SERVICE BULLETIN

No:	SB139-13	Issue:	2
Date:	27/08/13	Sheet:	Page 1 of 2

SUBJECT:	Volvo Engine Nox Sensor Failure

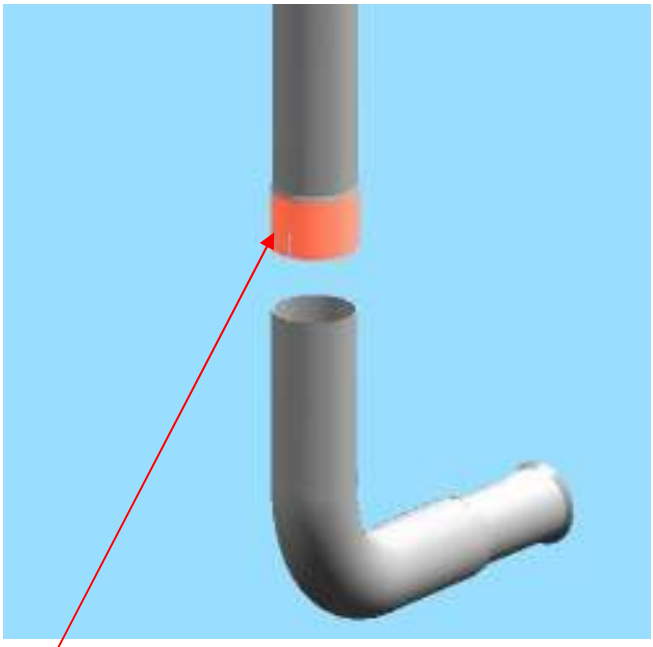
To attempt to alleviate Nox Sensor failure, Dennis Eagle have made available a 90º swept bend vertical exhaust outlet pipe which should help to prevent water ingress into the vehicle exhaust system and contamination of the Nox Sensor.

If the exhaust tailpipe has a swage, order part number 824028.
